December 2, 2022

NOTICE TO ALL BIDDERS

Re: TENNIS COURT, SHADE, AND LIGHTING PROJECT
RFP No 22-23-01
ADDENDUM #02

Document Date 06-29-22	Project Number 22-081V
	Date Last Revised 11-18-22	Reference Sheet AS3
	Sheet Number AD-02_AS3

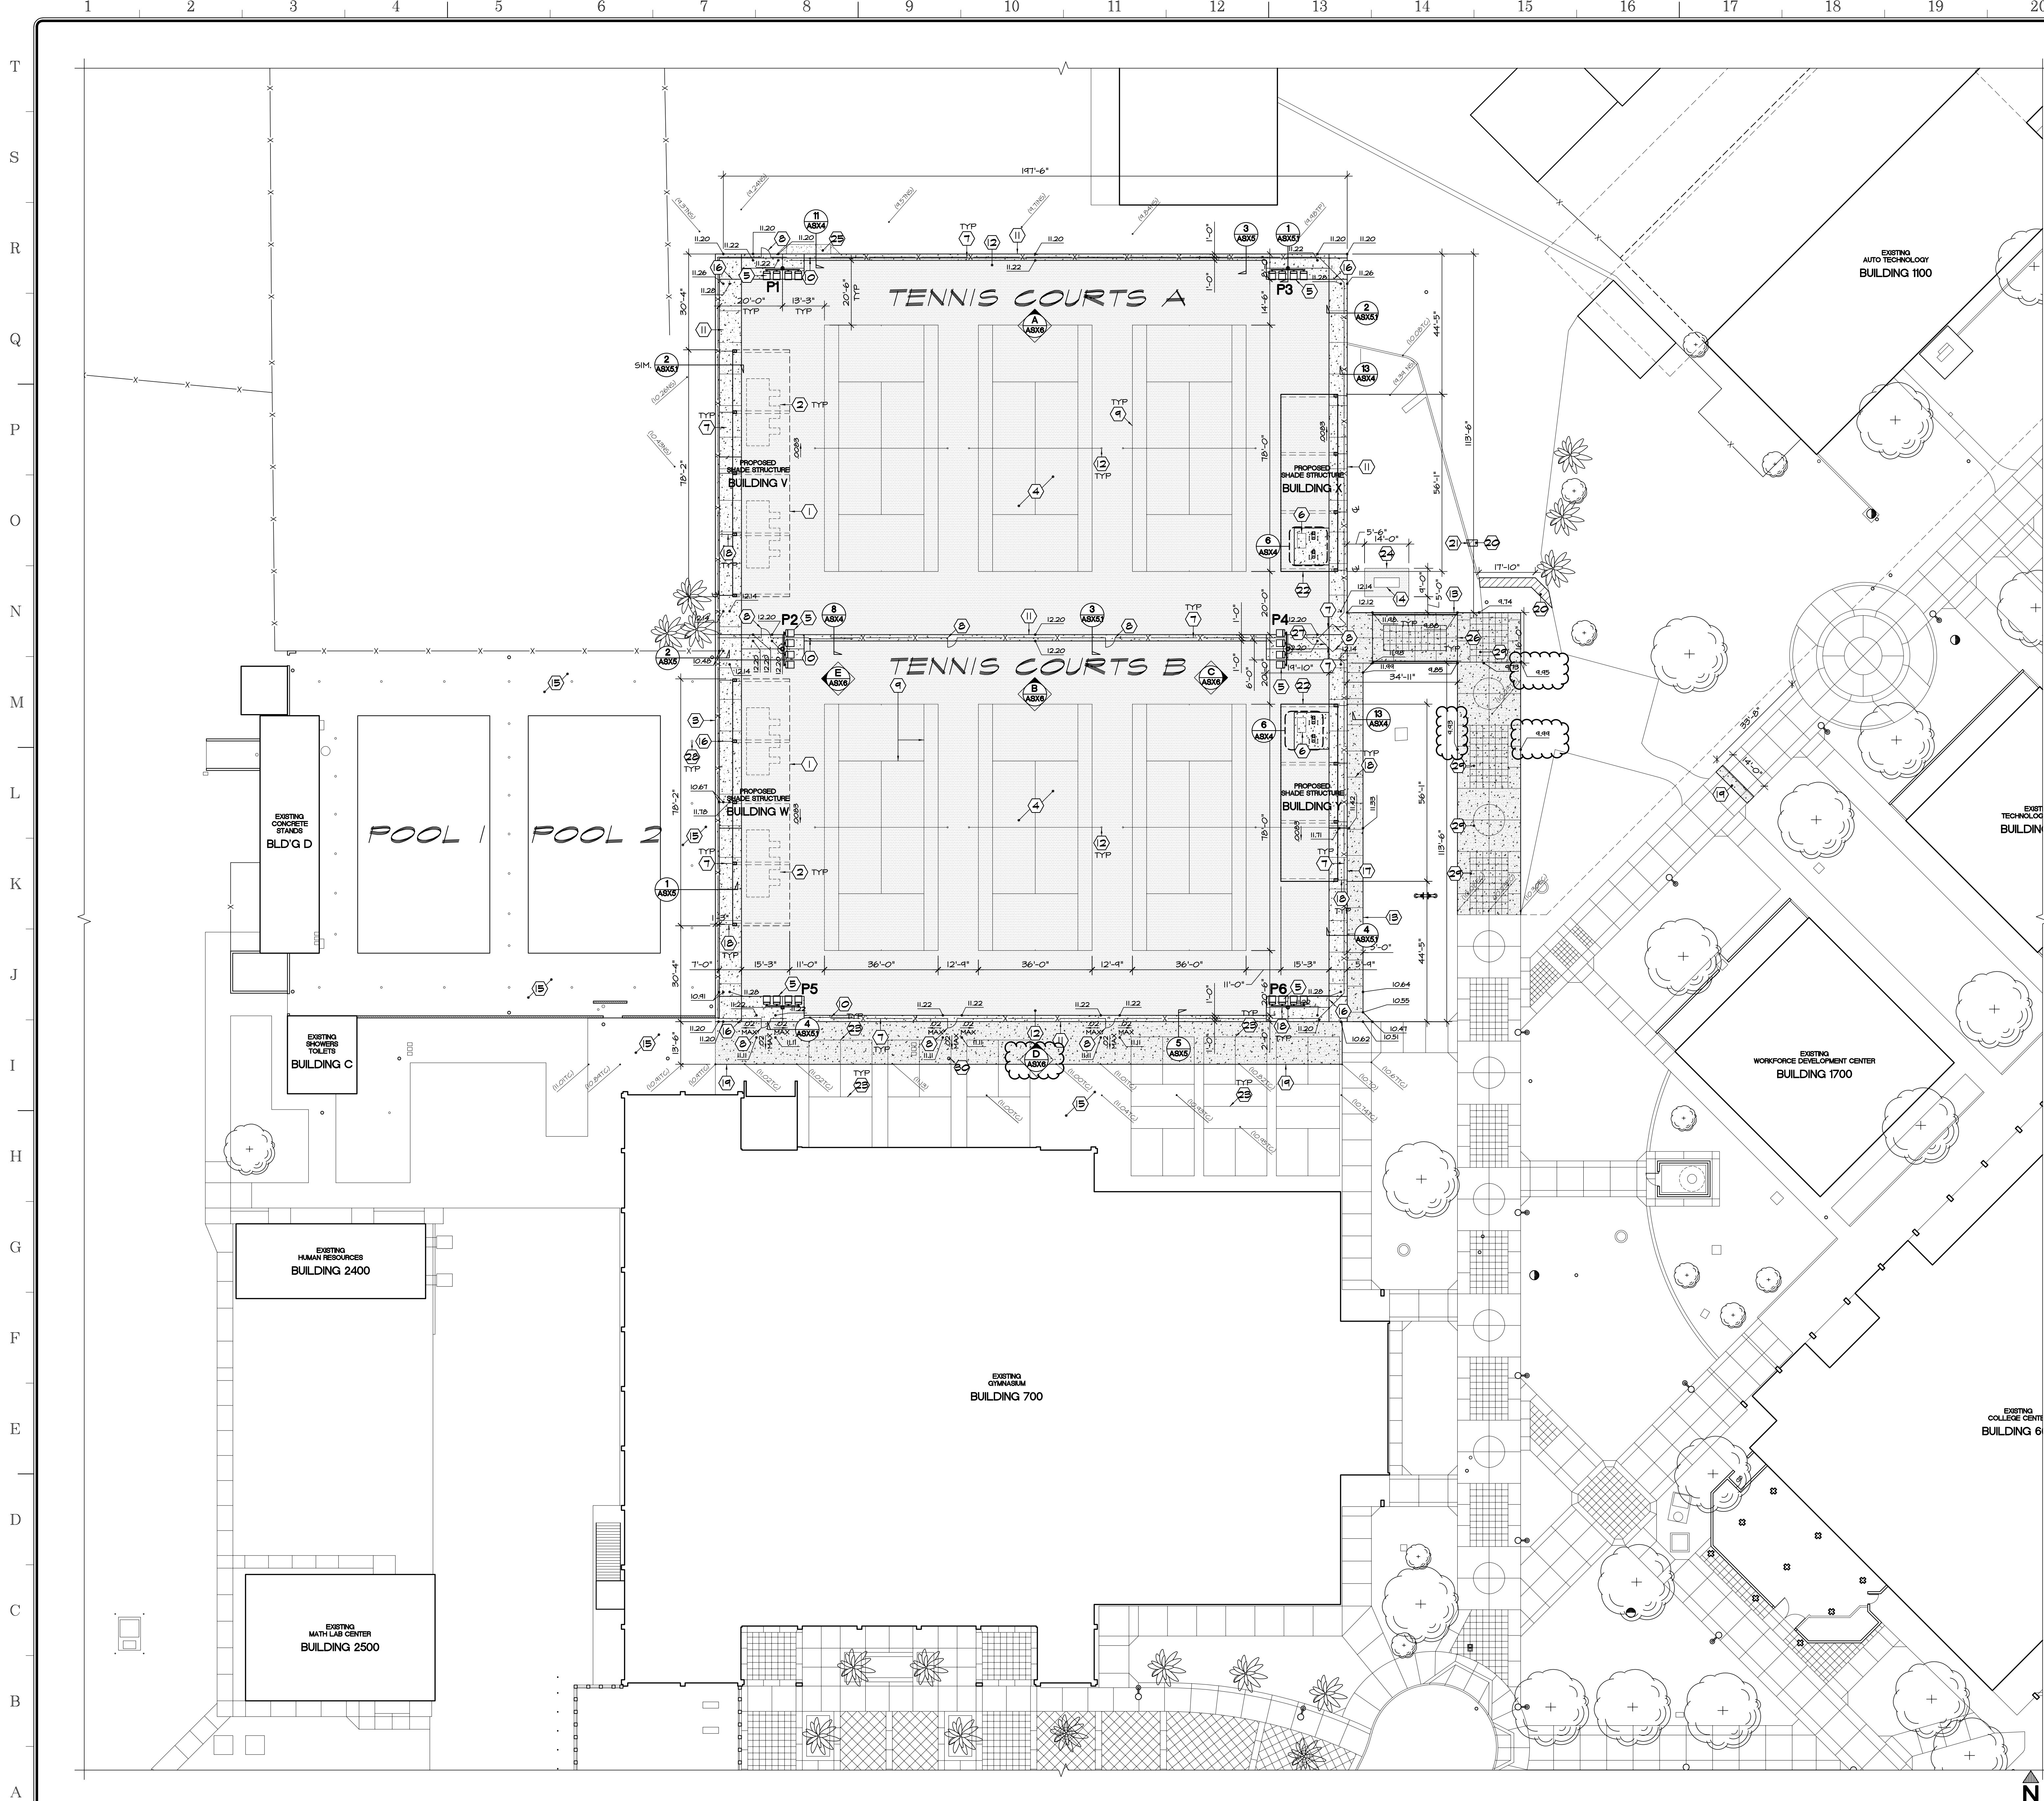
- A. Refer to attached Revised Plans Sheets.
4. Page AS3 states that the core samples taken from the existing Tennis Court (keynote L, M, N, and O) are Asphalt. Demolition keynote #1 states that the Tennis Court is a concrete slab. Please clarify whether the existing Tennis Court is Asphalt or Concrete.

- A. Refer to attached Revised Plans Sheets. Keynote no. 1 is in error. The tennis court is built from asphalt.
5. Page E101 note 7 calls for "4 #2 CU, 1 #4 CU GND" while the single line on page E201 calls for "4#1 CU and 1 #6 GND" Please clarify which one is correct.

ELECTRICAL FLOOR PLAN - 18' x 78' SHADE

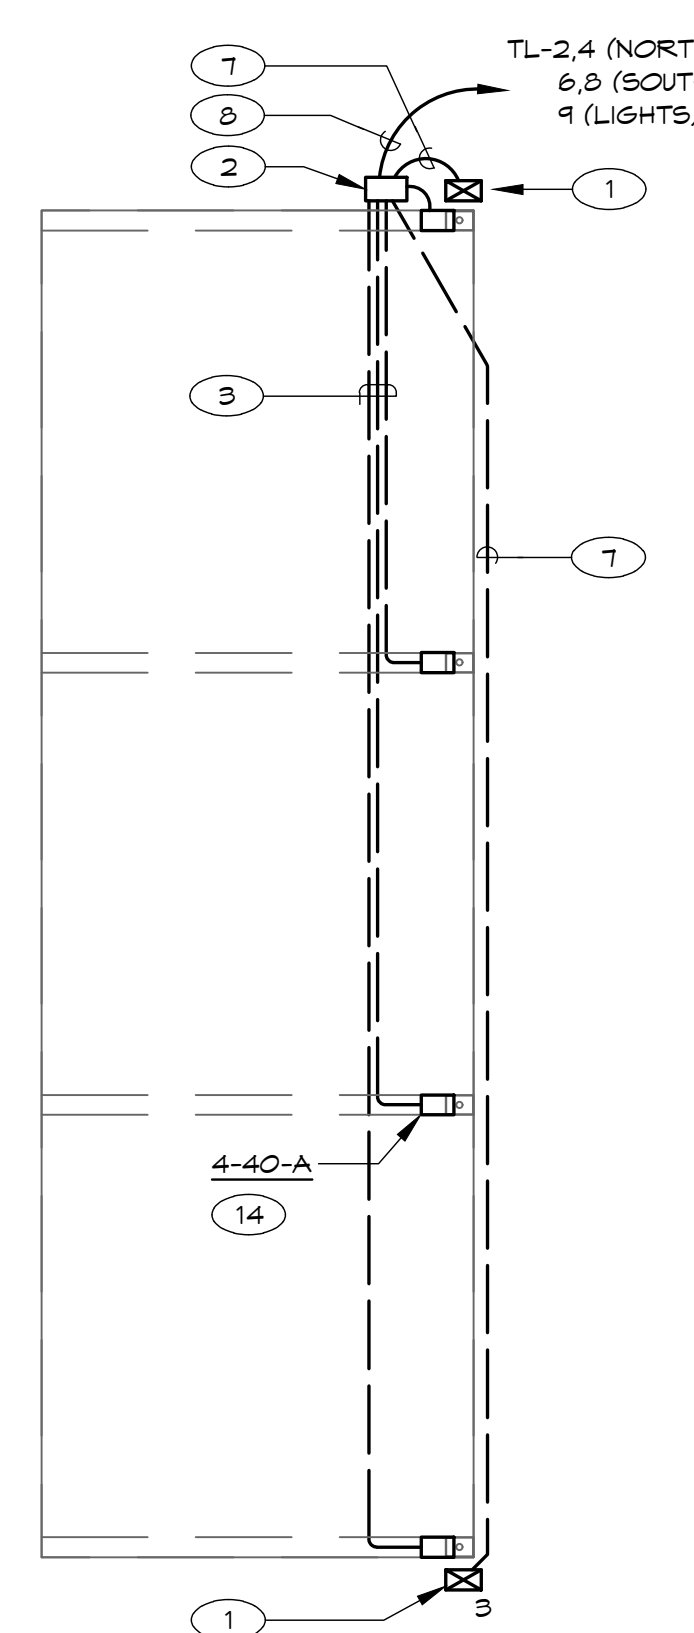
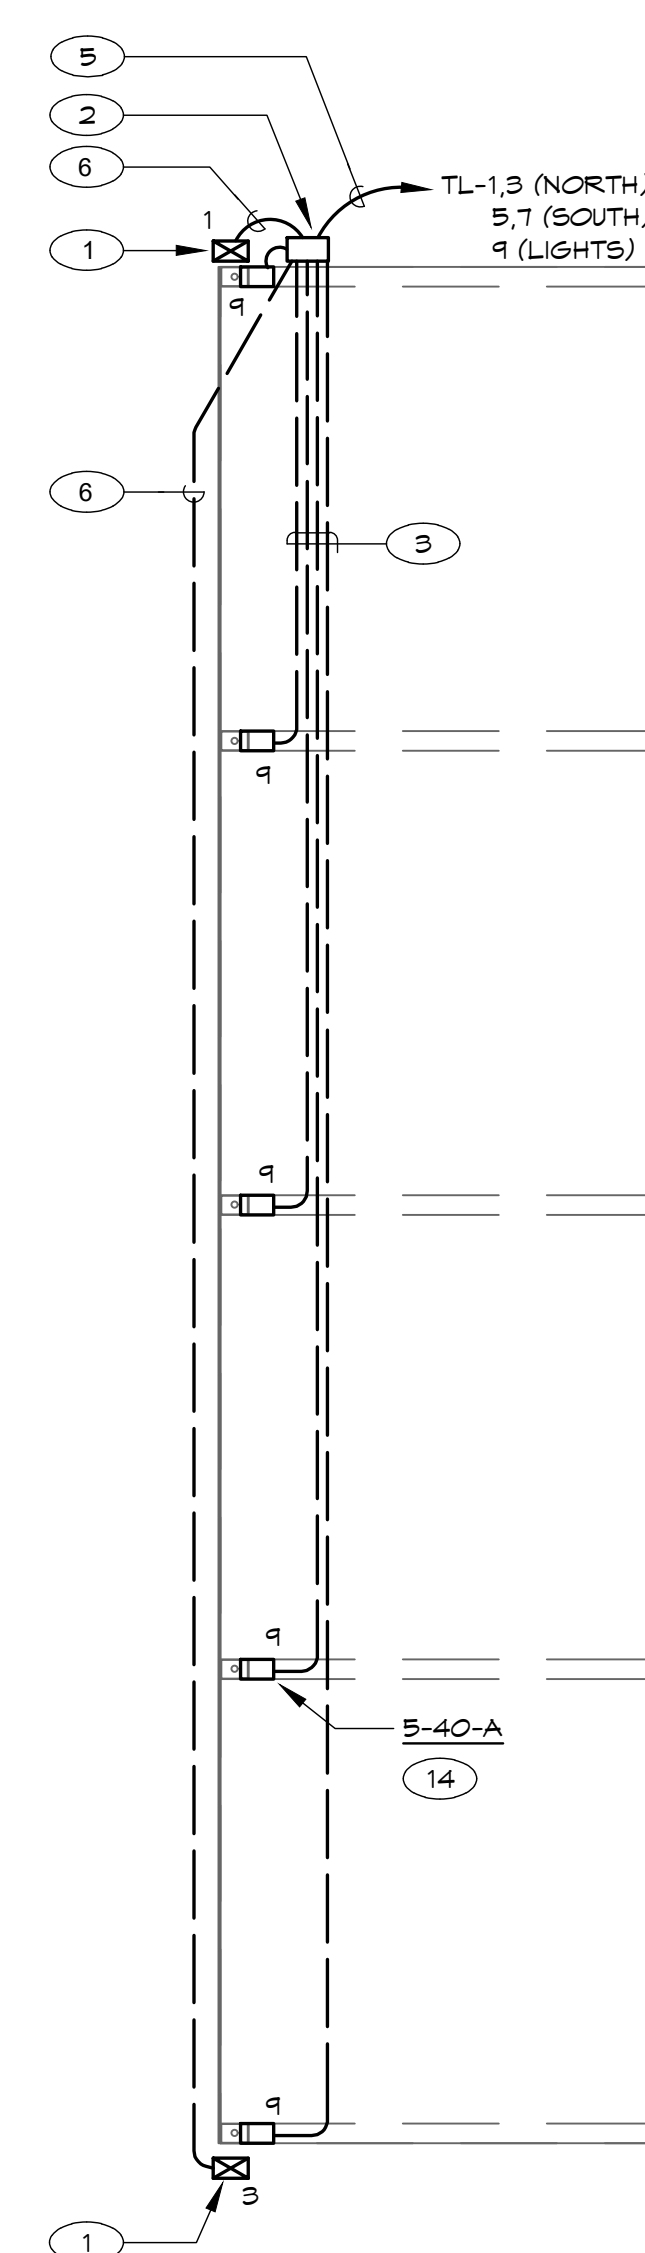
7. Addendum 02, Electrical Shade Structure Plan, E102, Note 5, shall be revised to state, "1 1/2" PVC. C., 3#6 CU and 1#10 CU GND (RECEPTACLES), 2#12 CU, 1#12 CU GND (LIGHTS)".
8. Please be advised that the Contractor is responsible for all lights, electrical fixtures, and lighting appurtenances, which are to be installed to the shade structures.

- A. Please see above Document Additions, Revisions and Clarifications section.
3. Page E102 shows a total of 18 lights mounted to the ceiling of the shade structures. Detail 14 points to these lights but is missing from the plans. Do the shade structures come equipped with the necessary lights? If not, please provide specs on these lights.

1. AD-03_E102 – ELECTRICAL SHADE STRUCTURE PLAN
